IDAP REPORT – SECTION 4.55(1A) MODIFICATION

Property:	35 Wakeford Road STRATHFIELD Lot: 7 DP: 15343 DA2020.249.3
Proposal:	S4.55(1A) Modification application for alterations and additions to an approved dwelling house.
Applicant:	Vision Group Architects
Owner:	T Ma and P Min
Date of lodgement:	5 July 2022
Notification period:	N/A
Submissions received:	Nil
Assessment officer:	G Choice
Estimated cost of works:	\$1,594,131.00
Zoning:	R2-Low Density Residential - SLEP 2012
Heritage:	No
Flood affected:	No
RECOMMENDATION OF OFFICER:	APPROVAL

Figure 3: Proposed ground floor plan

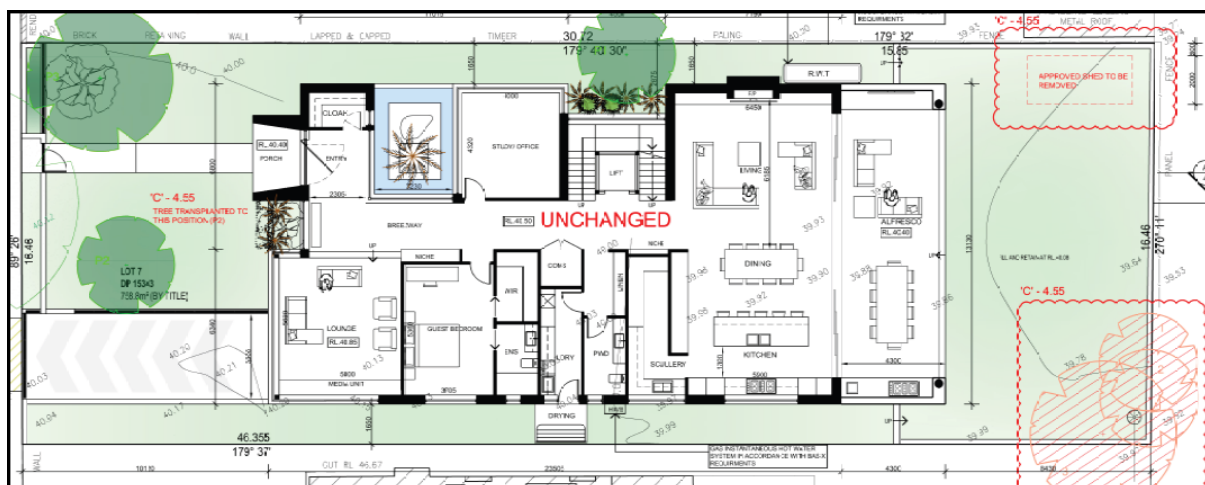
- Glazing removed next to entry door and above.
- Deletion of pond on western façade and replaced with landscaping
- Addition of two (2) new windows to the living room wall (west elevation)
- Reconfiguration of living room and dining
- Reconfiguration of powder room, guest en suite and laundry
- Living room pop-up height increased from 4m to 5.2m
- Ground floor to ceiling heights increased from 3m to 3.25m
- Modified glazing to living/dining area north elevation

Ground floor to ceiling heights are proposed to be increased. This includes the increased height of the living room pop-up height from 4m to 5.2m as well as an overall ground floor to ceiling heights increase from 3m to 3.25m. No change to the building height is proposed and the modification is considered acceptable.

Figure 5: Proposed first floor plan

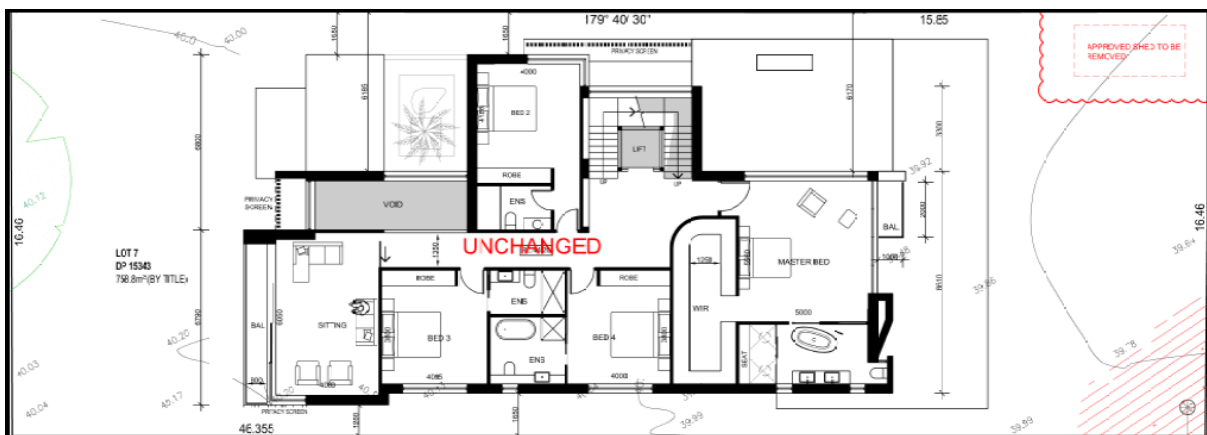
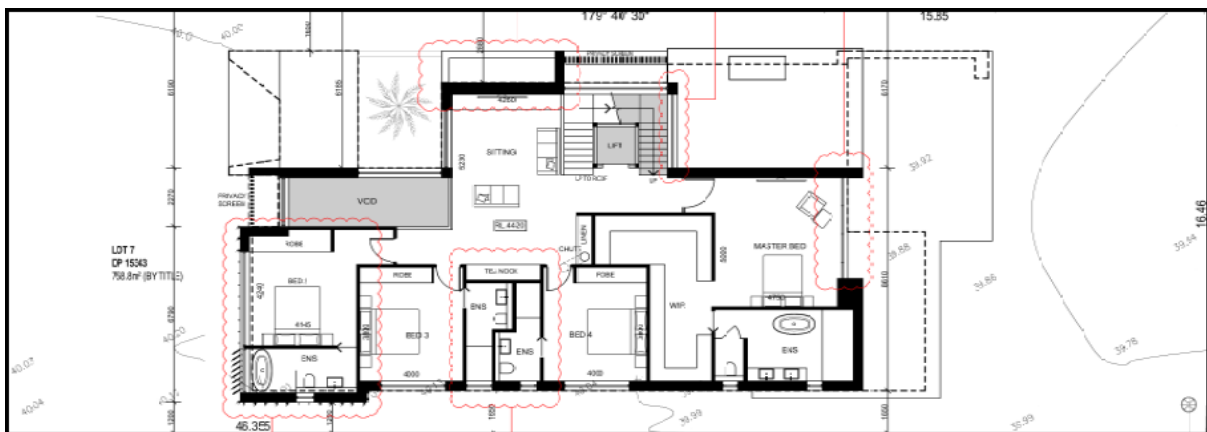
- Relocation of Bed 2 and sitting room
- Removal of balcony from front façade
- Increase setback to west elevation of new Bed 2
- Removal of rear Master bedroom balcony
- Reconfiguration of Bed 3 and Bed 4 en suite walls and windows
- New window from new sitting room overlooking west side lower courtyard
- Modified window and obscured glazing added to en suite Master bedroom
- New windows added to stairwell on north elevation

Figure 9: Proposed elevations

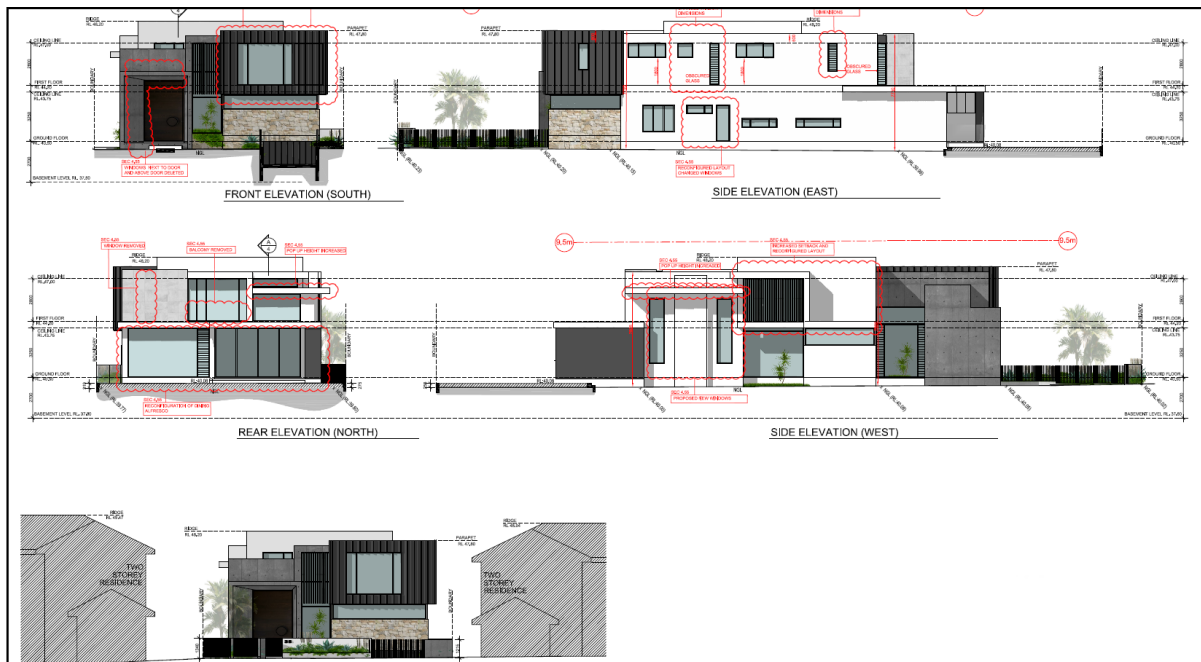
The front setback has been reduced from the approved 9m to 8.635m at the porch column feature, but remains consistent with the prevailing street setback and is, therefore, considered acceptable.
